SZC Proposed Hard Coastal Defence Positioning and CPMMP

Following a discussion between Paul Patterson (Coastal Protection East - CPE), Bill Parker, Tom Daly (Green District Councillor) and myself (Paul Collins) at the ONR meeting at Riverside Centre, Stratford St. Andrew on Thursday 25th May, we agreed that we should meet up at Sizewell, on a date to be agreed, and walk the proposed Sizewell C Hard and Soft Coastal Defence Features (HCDF and SCDF) to understand its position according to the final submission to the Planning Inspectorate Examination of the SZC Development Consent Order (DCO).

ISH 11 - 20 August 2021	14 April 2023

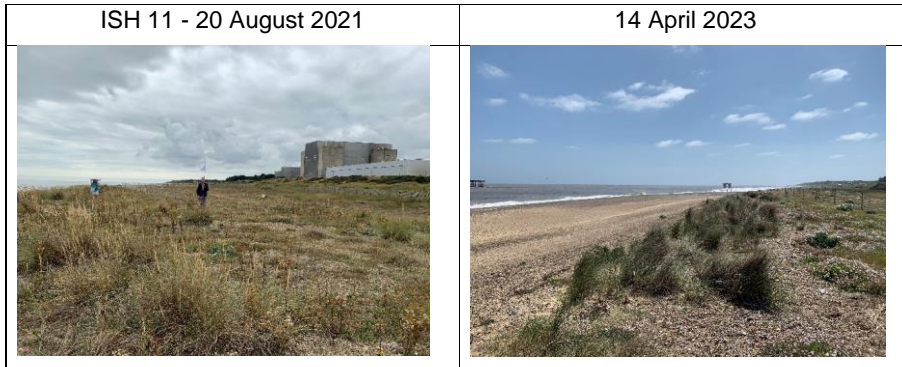
This position of the proposed HCDF toe is on the current SZB salient which has also been significantly eroded between the time when a picture was taken for the ISH 11 summary report referenced above and now. Both are shown below with 4-5 metres of shingle loss from the salient since 2021 along with erosion of the sacrificial dune all along the frontage from the Minsmere Sluice to the Sizewell salient.

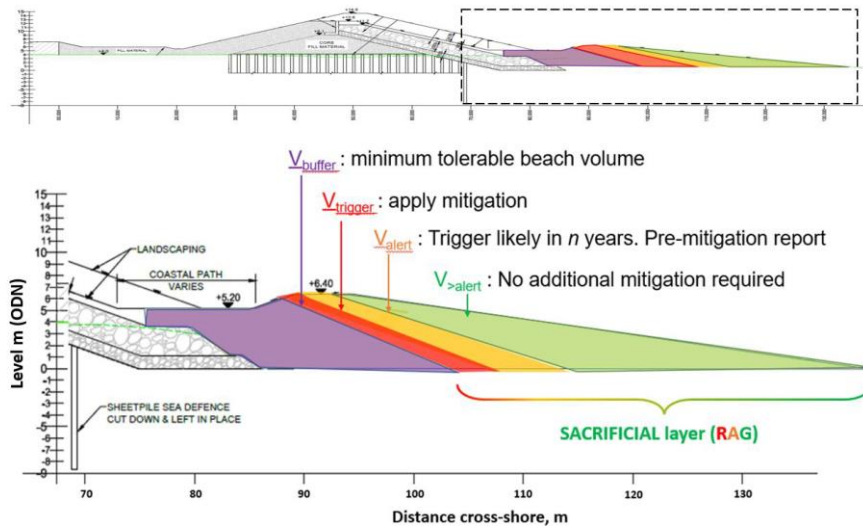
The current sacrificial dune height along the proposed SZC frontage varies roughly between +2mOD and +4mOD. The proposed footpath/track along the HCDF/SCDF will be directly above the initial HCDF toe at a height of +5.2mOD with the SCDF rising on the seaward side to +6.4mOD and then declining east to 0OD over ~65m at a slope of between 1:8.6 as shown below in the latest submission by SZC for discharge of Requirement 12 / DML Condition 14 of the CPMMP.

Unfortunately, this diagram and documentation does not clearly state where along the frontage this cross section of the HCDF/SCDF represents and as the HCDF design and position of the toe is still not fixed, the representation is technically meaningless.

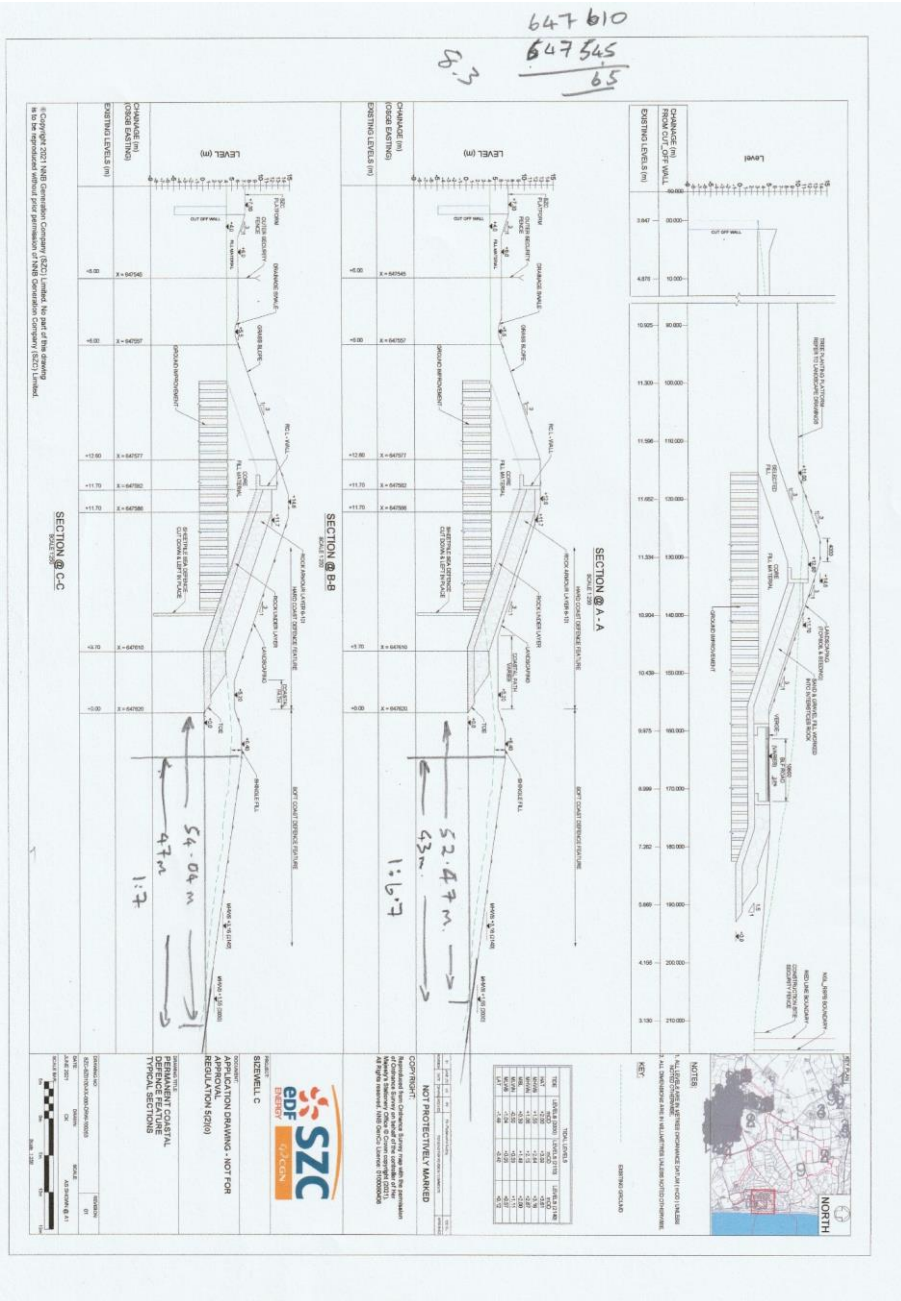
In the original DCO documentation, only two sections (B-B and C-C) of the coastal frontage of the HCDF/SCDF design are given in the Revision 2 plans (attached below).

These plans do not cover anything beyond the HCDF inflexion point or the south-eastern extremity of the HCDF given that the toe at this position is between 23m and 32m east of the toe positions at these two cross-sections based on these plans.

EDF have stated that the slope of the SCDF at the south-eastern extremity will have to be steeper and based on its toe position above, this will mean a slope of between 1:3.8 ((47-23)/6.4) and 1:1.8 ((43-32)/6.4), neither of which would be sustainable for a shingle/sand substrate.

What's more given the precarious initial position of this complex on the coast and the impacts from sea level rise and climate change, the plan to extend the toe out a further 17m and to a depth of -1.5mOD as an Adaptive Sea Defence (shown at section B-B) seems even more unrealistic, especially when the proposed position of the south-eastern extremity is considered.
